Service Letter No. 364A (Supersedes No. 364)

SUBJECT: Detached or Loose Rubatex Blocks in Wing Panels

MODELS AFFECTED: PA-24 and PA-24 "250" Comanches - Serial Nos. 24-1 to 24-2264 inclusive

SERVICE LETTER NO 364 A

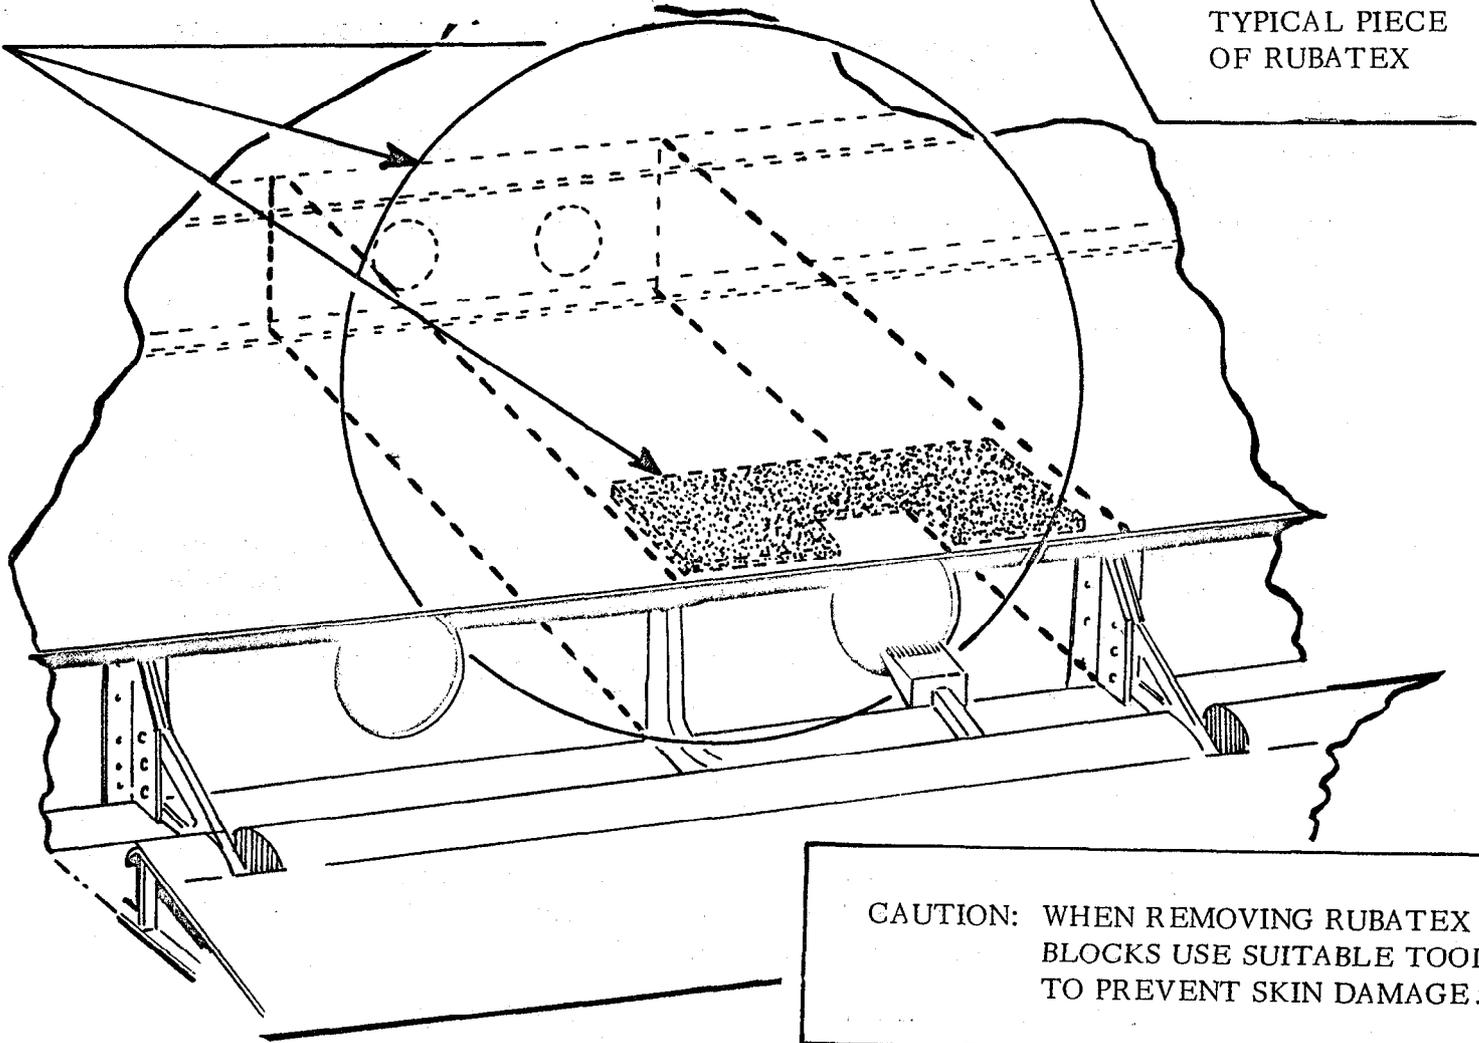
Rubatex blocks were used in a few instances to reduce the tendency of oil canning in the areas of the wing panels, as shown on the sketch on the reverse side of this Service Letter. Prior to but not later than the next 50 hours of operation, this entire area on both wings must be inspected and where these blocks are observed either loose or attached, they are to be removed.

REMOVE ALL RUBATEX FOUND IN
THIS AREA - UPPER AND LOWER SKINS

TYPICAL PIECE
OF RUBATEX

CAUTION: WHEN REMOVING RUBATEX
BLOCKS USE SUITABLE TOOL
TO PREVENT SKIN DAMAGE.
